**Re: Section 16 Planning Application for Temporary Private Vehicle Park (Freezer Vehicles Only) with Ancillary Site Office for a Period of 3 Years at Lot Nos. 401 (Part), 404 (Part), 405 RP (Part), 406 RP, 408 RP (Part), 409 and 410 (Part) in D.D. 106, Pat Heung, Yuen Long, New Territories
(Planning Application No. A/YL-KTS/1061)**

Further Information

Response-to-Comments

Drainage Proposal

Title:
Swept Path Analysis
for 7m Vehicle

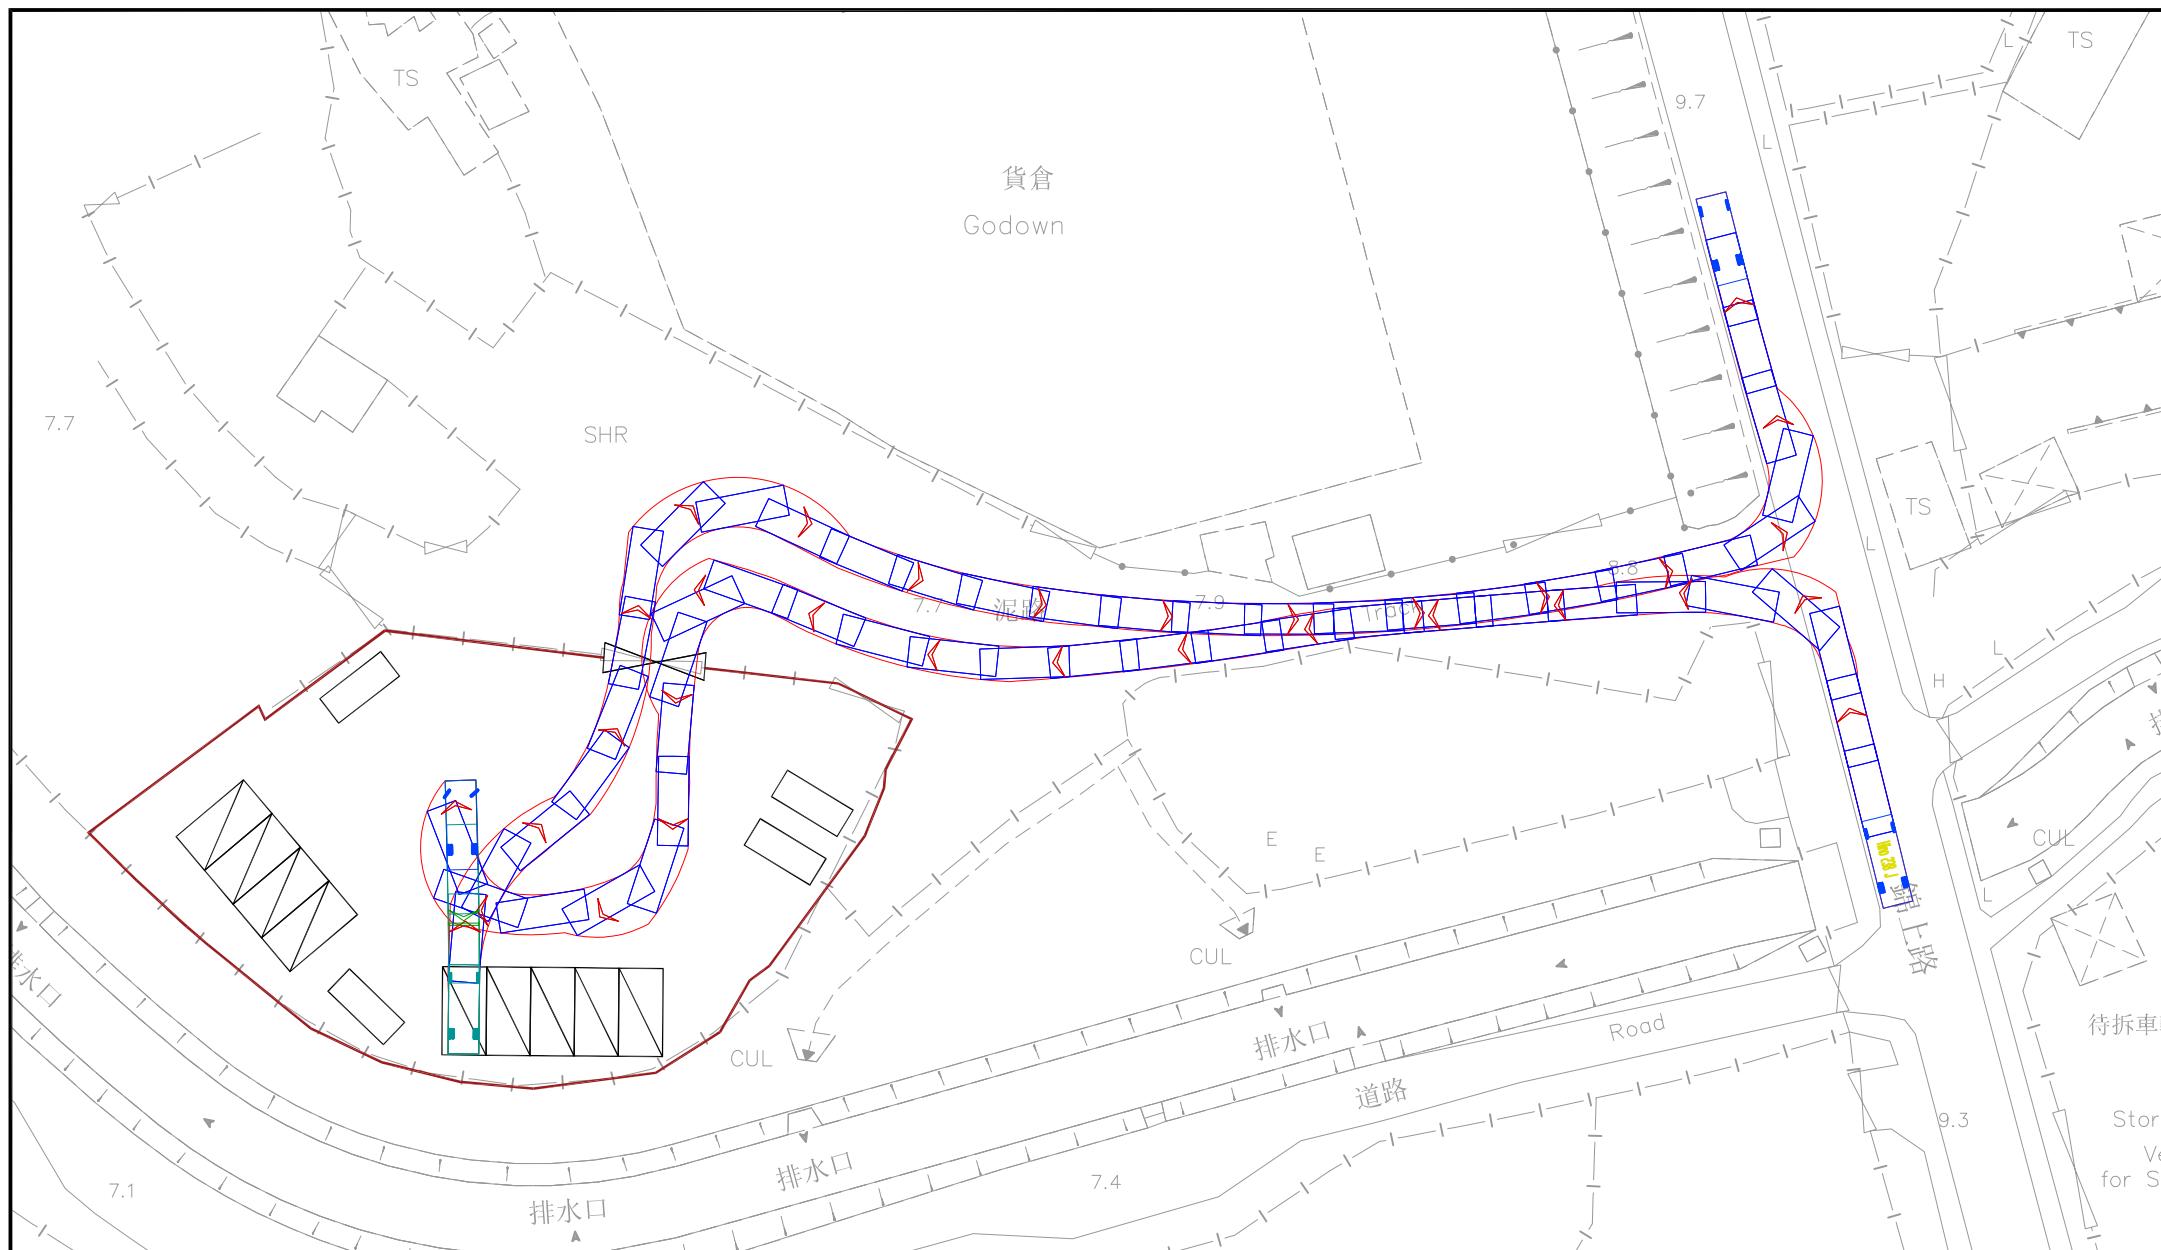
Department	Date	Comments	Responses to Departmental Comments
Transport Department	20.3.2025	a) The applicant should demonstrate the smooth manoeuvring of vehicles to / from Kam Sheung Road, along the local access and within the site;	Sufficient space is provided to ensure smooth maneuvering of vehicles to / from Kam Sheung Road, along the local access and within the application site. Please refer to the attached swept path analysis.

DRAWING NO: WAC/24294/C/DRA/001 REV: -

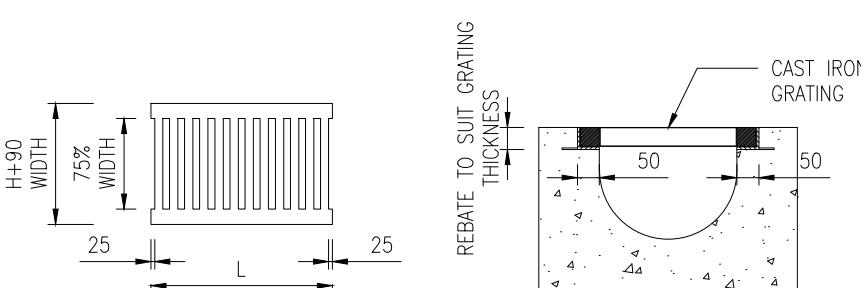
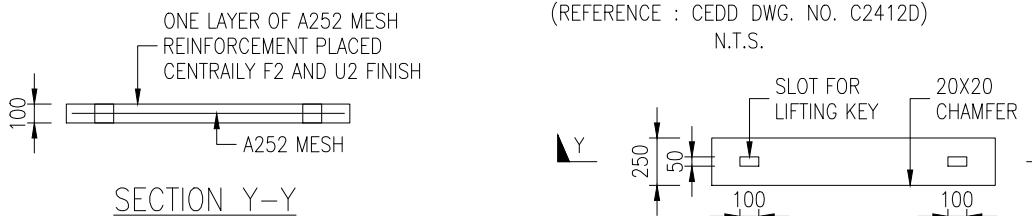
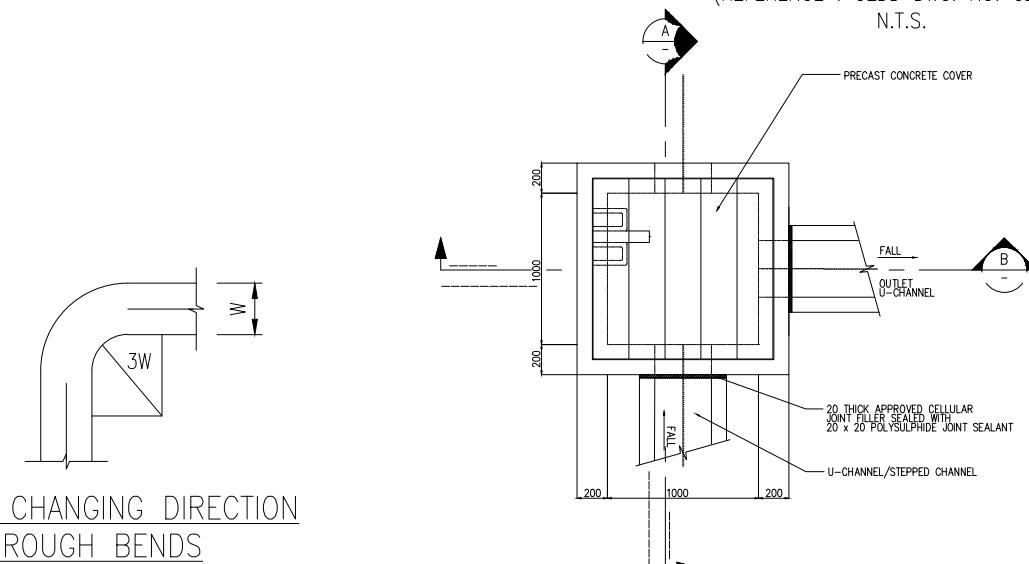
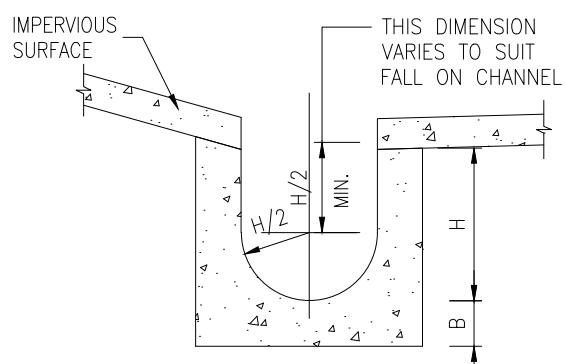
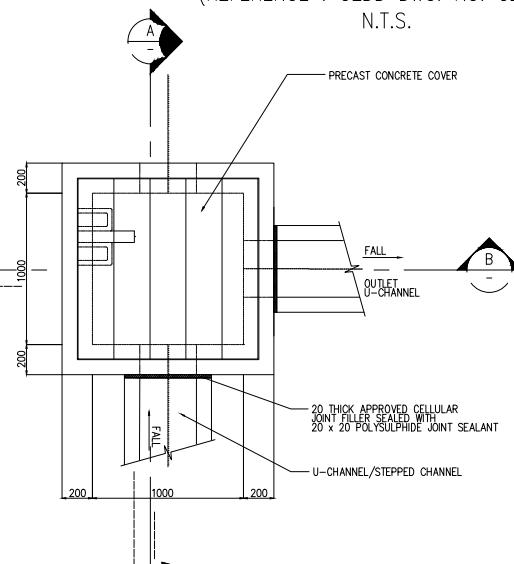
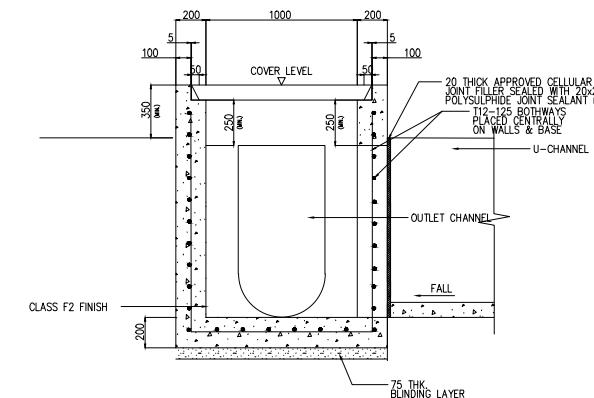
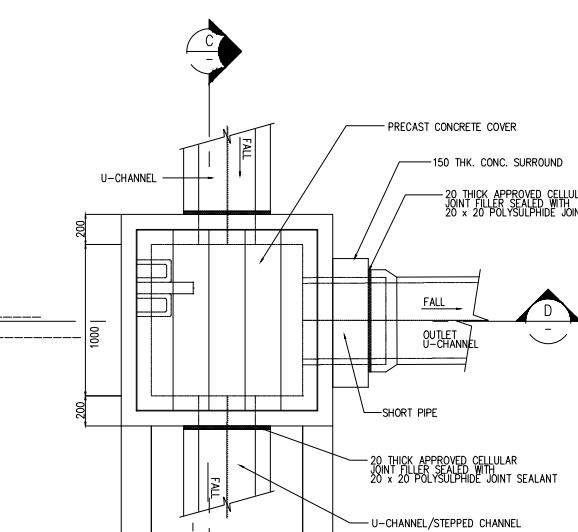
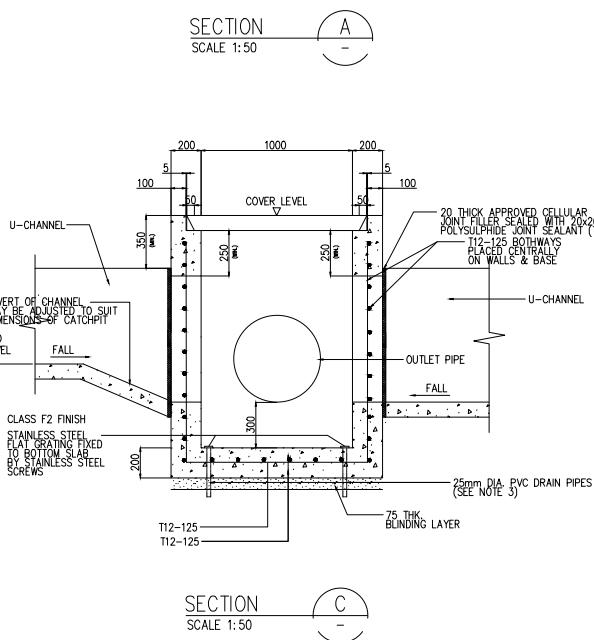
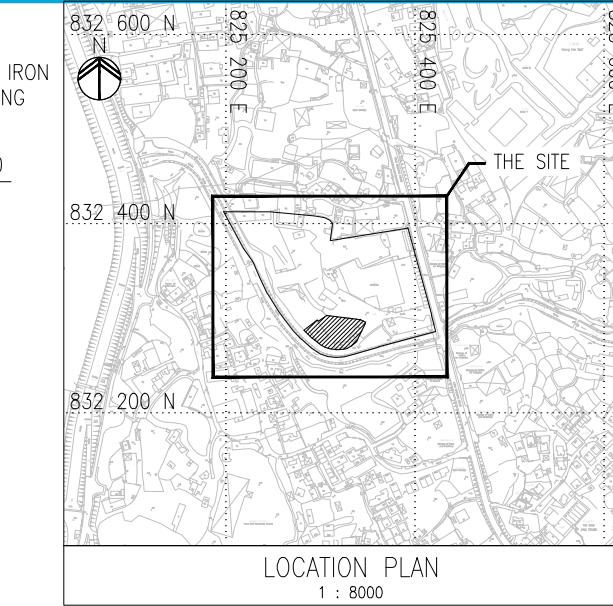
d) Please show the connection details at discharge point and indicate all C.L., L.L. and catchpit/watercourse bottom level in the drawing.	Please refer cross section C in WAC/24294/C/DRA/004 for the connection details of pipe with existing culvert at discharge point. The C.L., I.L. and bottom level are indicated in drawing WAC/24294/C/DRA/001.

h) Standard details should be provided to indicate the sectional details of the proposed u-channel and the catchpit/sand trap.	Standard details of proposed u-channel and the catchpit/sand trap can be found in drawing no. WAC/24294/C/DRA/001.

h.	Standard details should be provided to indicate the sectional details of the proposed u-channel and the catchpit/sand trap.	Standard details of proposed u-channel and the catchpit/sand trap can be found in drawing no. WAC/24294/C/DRA/001.

DRAWING NO:
WAC/24294/C/DRA/004

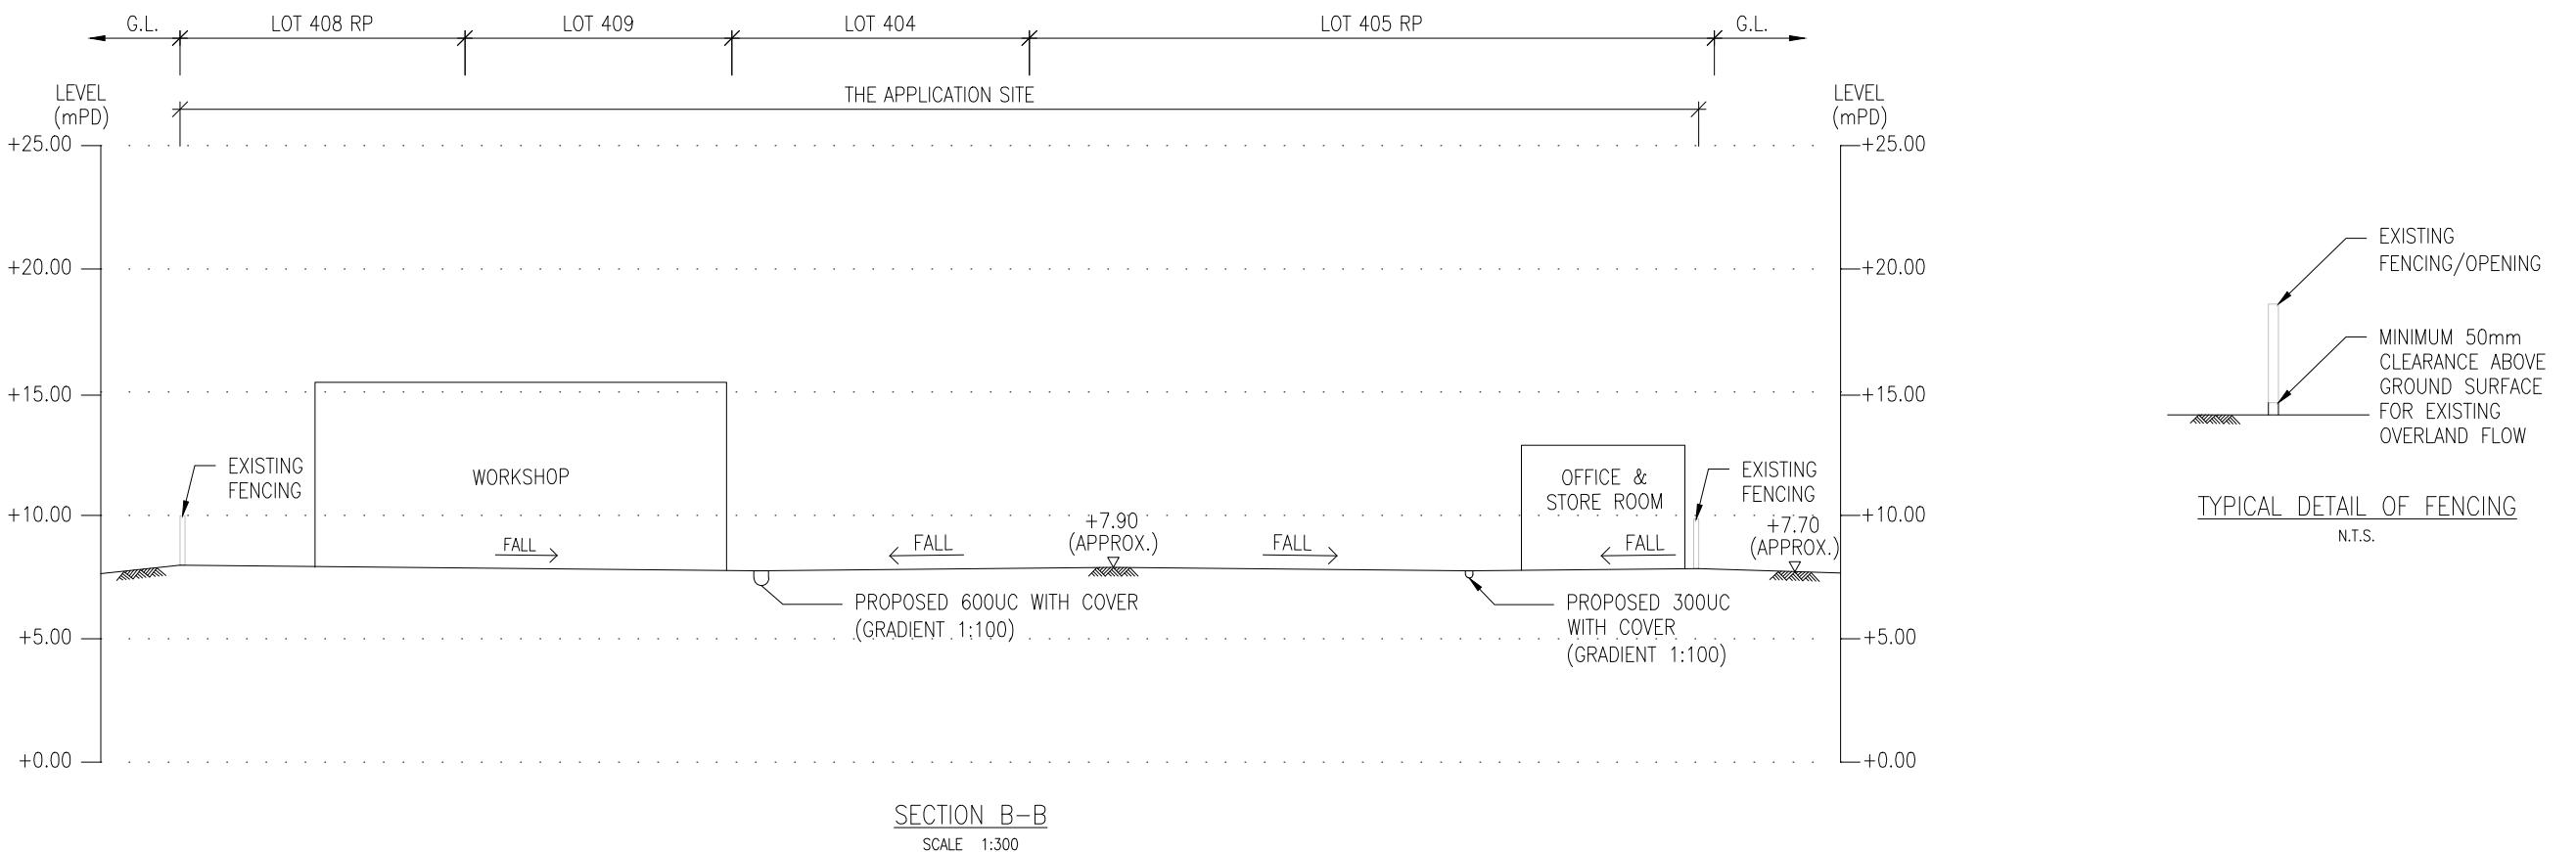
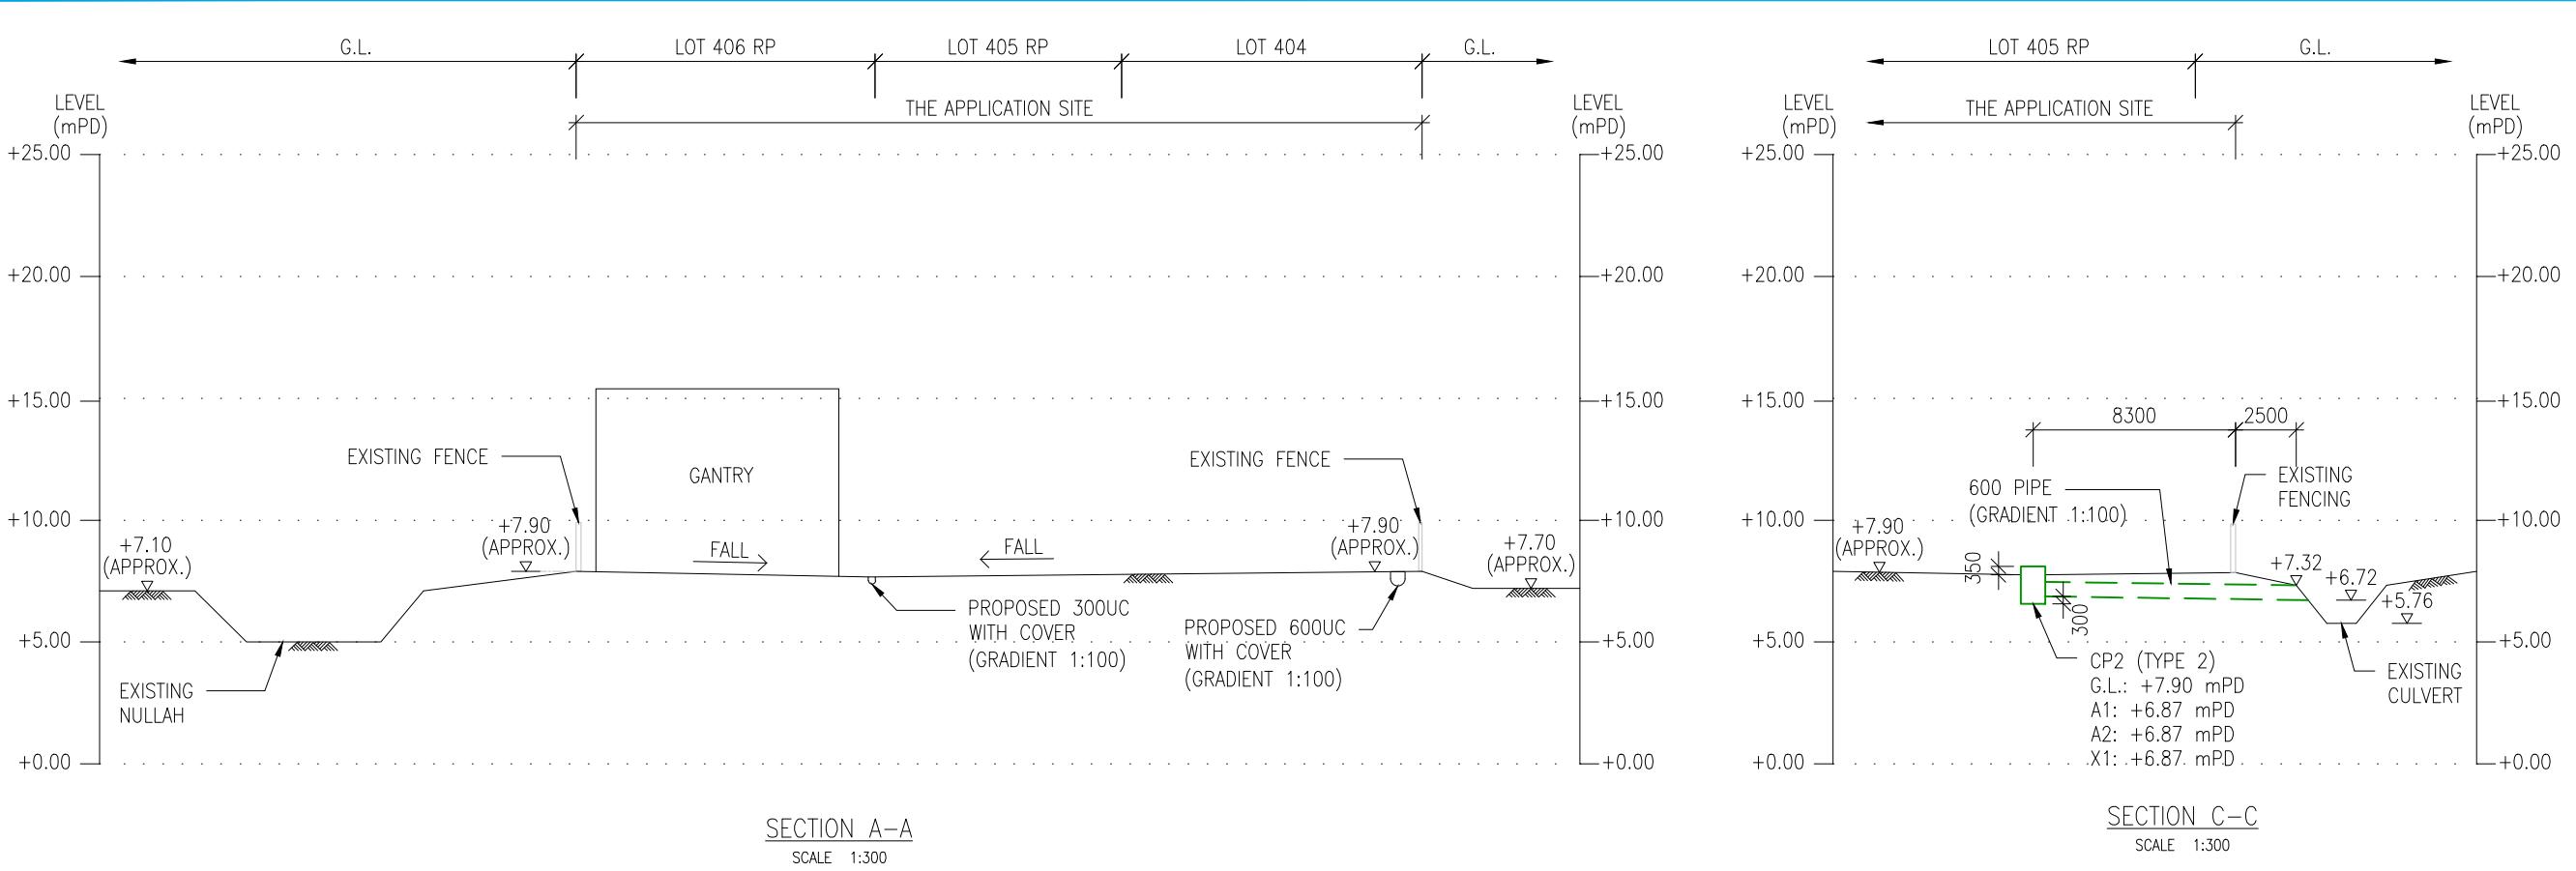
d.	Please show the connection details at discharge point and indicate all C.L., L.L. and catchpit/watercourse bottom level in the drawing.	Please refer cross section C in WAC/24294/C/DRA/004 for the connection details of pipe with existing culvert at discharge point. The C.L., I.L. and bottom level are indicated in drawing WAC/24294/C/DRA/001.
